Delta-Mendota Canal/ California Aqueduct Intertie

Final Environmental Impact Statement

Volume III: Responses to Comments

Volume III— Responses to Comments on the DEIS

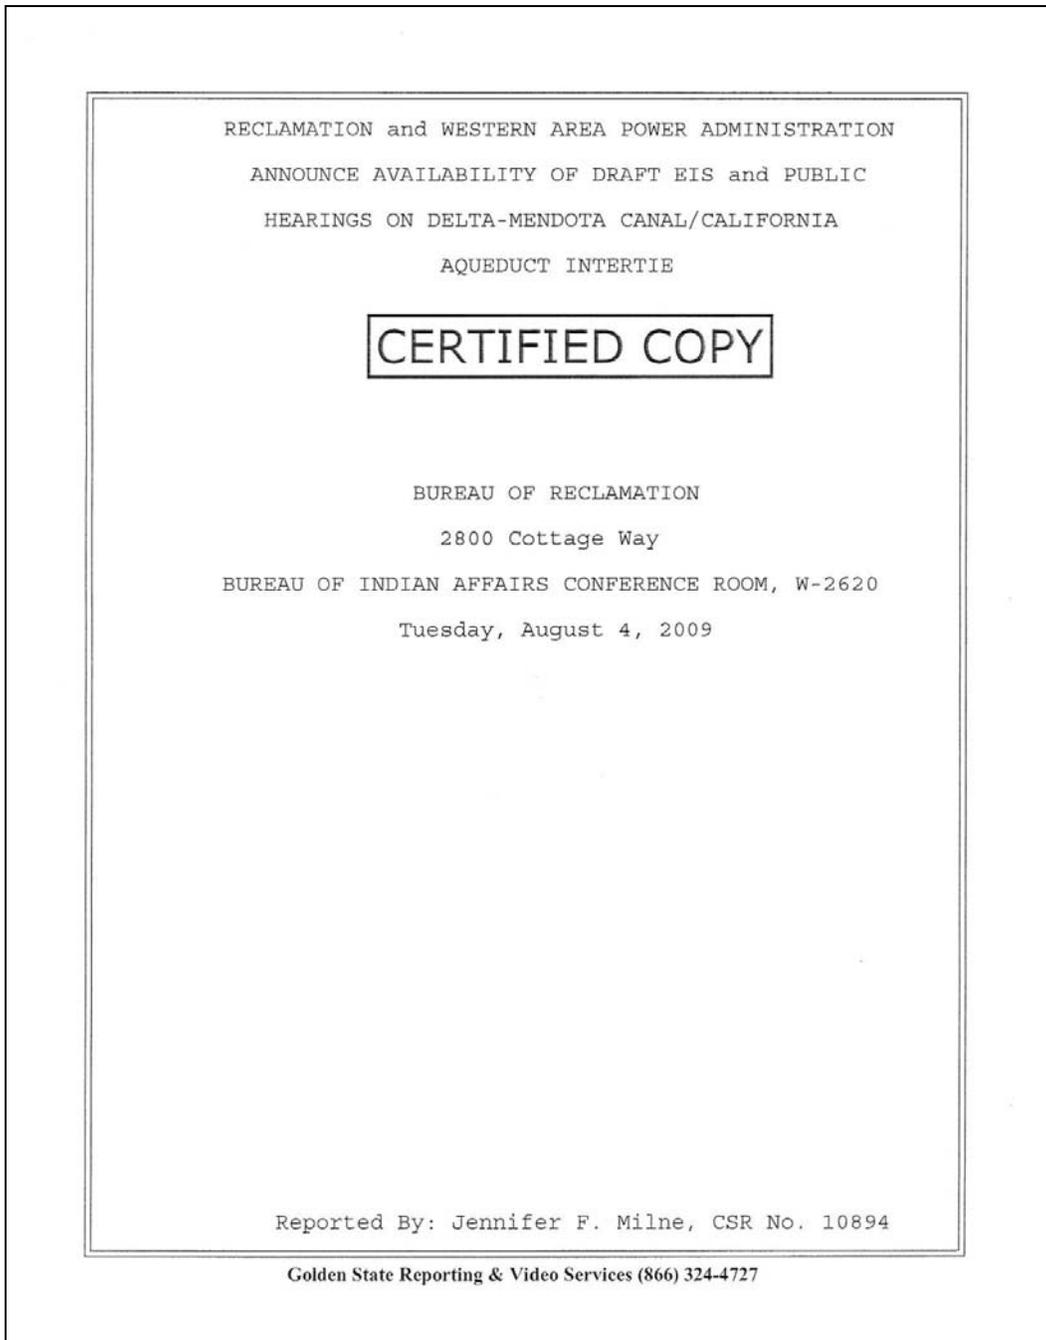
July 22, 2009. Dear Mr. Louis Moore, Federal Bureau Of Reclamation, 2800 Cottage Way MP-140, Sacramento, CA. 95825: My remarks are related to THE PROJECT regarding OFFICIALS connecting two massive canals that are about 500 feet apart just south of The Sacramento-San Joaquin River Delta , that is, the State of California California Aqueduct and The Federal Delta-Mendota CANAL to funnel water-agua- in the Billions of Gallons to Southern Californians and to millions of farmland acres which is endangered by various political forces such as the activists who are active in saving endangered species such as fish of certain types, ETC.--appears to be the Environmentalist Groups to me-- and which put in severe long-term jeopardy many communities in The San Joaquin Valley Region from Kern County to Sacramento County. With that introduction, Sir, may I proceed. The U.S. Federal protections for dying fish species in the Delta must be appropriately modified and modernized to allow the Billions of Gallons of Water to be sent to Communities and Farmlands that are dying right now too and consequently creating monstrous unemployment-jobless high rates and the destruction of aforementioned entities and creating loss of livelihoods and the loss of Revenue to sustain those said entities. You gotta fix the Problem so that it works better and brings better Constructive Consequences for those affected negatively and for those harmed and for those that are jobless, ETC. EXCEDREN, SIR!!! Cordially Yours, Reyes N. Monreal. Sanger, California 93657. 559-8757224. Internet email address is jalisco39@msn.com. Ciao and Shalom. Adios for now Mr. Government Man Louis Moore. May God Bless You and Your Federal Agency and may you have a great Day, Summer, Fall, Winter and Spring too. RNM.
